SUBJECT: Revised Core Operating Limits Report for Indian Point Unit 3 –
Mid-Cycle Revision
Docket No. 50-286
License No. DPR-64

Indian Point 3 COLR – Mid-Cycle Revision for Cycle 16

3-GRAPH-RPC-16 , Revision: 2

CORE OPERATING LIMITS REPORT

Figure 1
Reactor Core Safety Limit – Four Loops in Operation

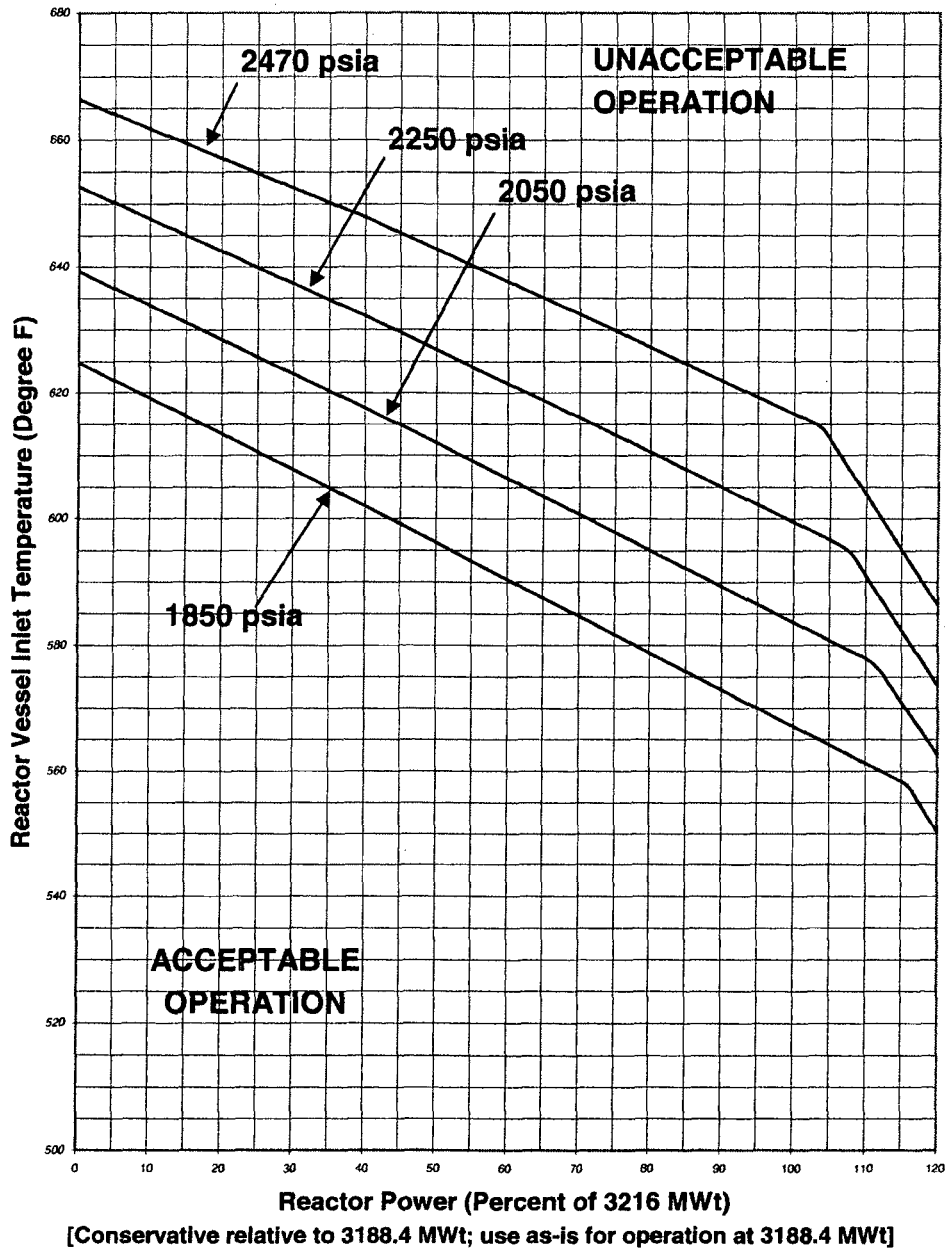
2.1 This revision corrects an editorial error in the COLR. The Indian Point Unit 3 Cycle 16 COLR text for "TS 2.1.1 Reactor Core SLs" has been revised for consistency with "Figure 1 Reactor Core Safety Limit – Four Loops in Operation" in COLR, as well as the Indian Point Unit 3 Technical Specifications. This revision is not considered a significant safety concern. The guidance that was presented in the COLR text would have resulted in a conservative determination of a safety limit being exceeded when applied to the COLR Figure 1 since Reactor Vessel average temperatures would have been compared to limits on Reactor Vessel inlet temperatures.

In MODE 1 and 2, the combination of thermal power level, pressurizer pressure, and Reactor Vessel inlet temperature SHALL not exceed the limits shown in Figure 1. The safety limit is exceeded if the point defined by the combination of Reactor Vessel inlet temperature and power level is at any time above the appropriate pressure line.
